Kennecott Uranium Company's Comments on DRAFT REGULATORY GUIDE DG-8051 -
BIOASSAY AT URANIUM MILLS (Federal Register Volume 77, Number 49 / Tuesday, March
13, 2012 / Notices)

Subject: Kennecott Uranium Company Comments on DRAFT REGULATORY GUIDE DG-8051- BIOSSAY AT URANIUM MILLS (Federal Register Volume 77, Number 49 /Tuesday, March 13, 2012 /Notices) Docket ID NRC-2012-0057

RE: Review of Paper "Solubility of Radionuclides in Simulated Lung Fluid", G. Tairova et al, 2010

Figure 5 - Dissolution kinetics of concentrate samples

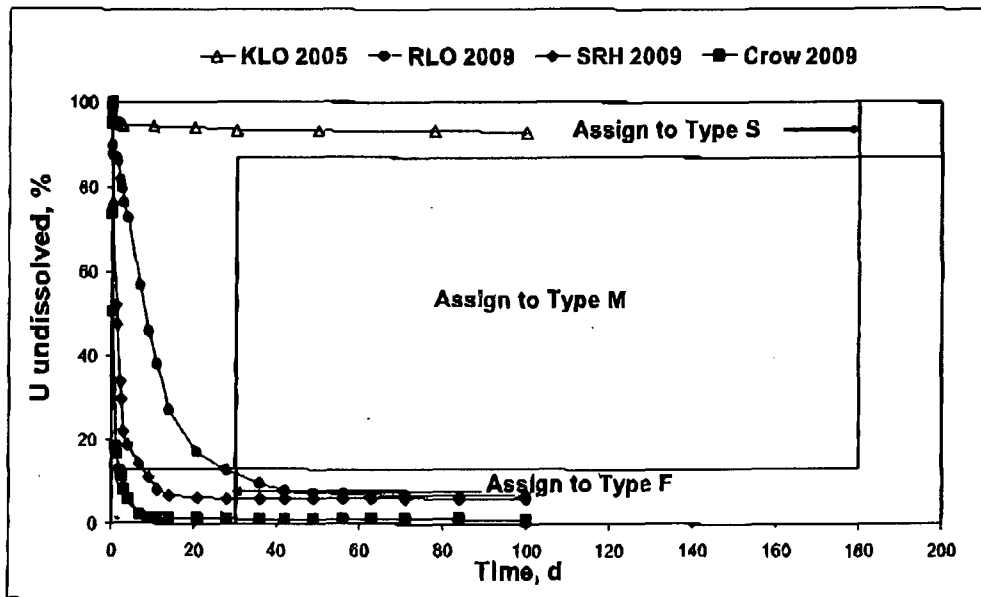
All ISR samples appear to exhibit solubility characteristics that meet the definition of absorption Type F as defined in ICRP 71 (i.e. the most soluble category) - see paper Figure 5. ICRP 71 considers Type F as "generally equivalent" to solubility Class D from the older ICRP 26/30. ICRP26/30 is the basis of 10 CFR 20 dosimetry (Uranium Derived Air Concentrations {DACs} and Annual Limits on Intake {ALIs} in 10 CFR 20, Appendix B, Table 1 .

1. All ISR samples appear to exhibit solubility characteristics that meet the definition of absorption Type F as defined in ICRP 71 (i.e. the most soluble category) - see paper Figure 5. ICRP 71 considers Type F as "generally equivalent" to solubility Class D from the older ICRP 26/30. ICRP26/30 is the basis of 10 CFR 20 dosimetry (Uranium Derived Air Concentrations {DACs} and Annual Limits on Intake {ALIs} in 10 CFR 20, Appendix B, Table 1).

The Regulatory Guide should be revised to reflect this information in our Appendix 1.
